**RESPONSE TO REQUEST FOR ADDITIONAL INFORMATION REGARDING
CHANGE TO TECHNICAL SPECIFICATION RELATING TO CONTAINMENT
CLOSURE AND FUEL HANDLING VENTILATION
SALEM GENERATING STATION UNIT NOS. 1 AND 2
FACILITY OPERATING LICENSE NOS. DPR-70 AND DPR-75
DOCKET NOS. 50-272 AND 50-311**

**SALEM GENERATING STATION
UNIT NOS. 1 AND 2
FACILITY OPERATING LICENSE DPR-70 AND DPR-75
DOCKET NOS. 50-272 AND 50-311
RESPONSE TO REQUEST FOR ADDITIONAL INFORMATION
CONTAINMENT CLOSURE AND FUEL HANDLING AREA VENTILATION**

Figure 1

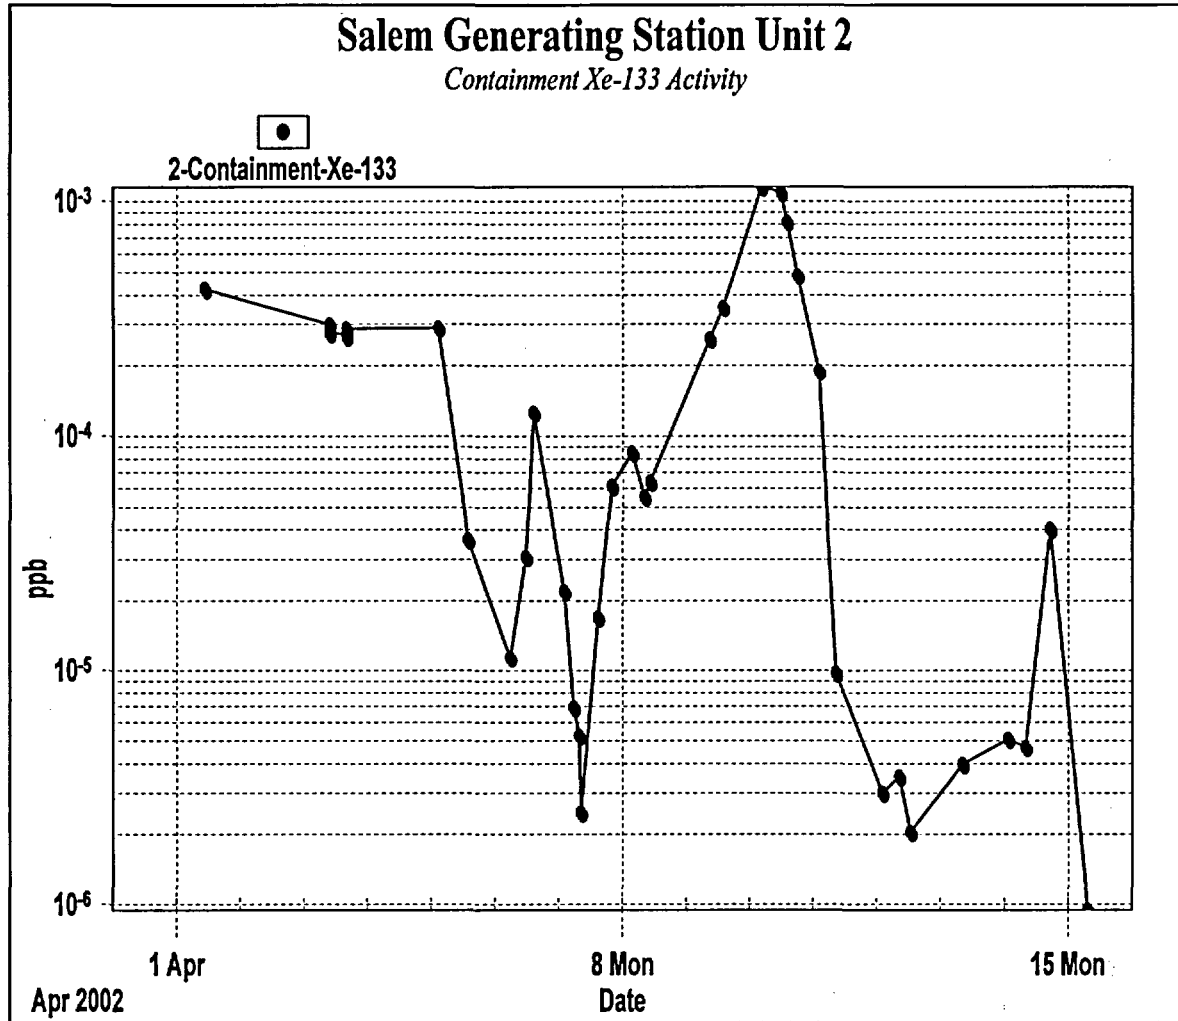
According to the submittal, the containment purge system and the auxiliary building ventilation systems can draw a negative pressure on the containment with the equipment hatch open. Describe the analyses that were performed to verify that these systems can draw down the containment with the equipment hatch open.

The ability to draw a negative pressure on the containment was based on past operating experience. As an example, during the Unit 2 12th refueling outage high airborne activity in the containment caused an automatic isolation of the containment purge system, which isolated the ventilation flowpath in and out of containment. To reduce the airborne activity in containment, the personnel airlocks and the refueling outage equipment door were opened with the Auxiliary Building Ventilation System (ABVS) in service to allow the ABVS to draw the air out of containment and reduce the containment airborne activity. As shown in Figure 1 and Table 3, the containment airborne activity level decreased which demonstrated the ability of the ABVS to draw the air from the containment with the personnel airlocks open. The exhaust from the ABVS is monitored by the plant vent radiation monitors.

The Salem ABVS design includes the required line-ups to purge the containment. The ABVS supply fans provide the purge supply air into the containment and the ABVS exhaust fans draw the purge exhaust out of containment. The use of the containment purge flow path or, the personnel airlocks with the ABVS in service and the equipment hatch open will allow the ability to monitor the release following the FHA until containment closure can be accomplished.

The data provided in Figure 1 and corresponding Table 3 supports the justification for the statements made in the PSEG submittal.
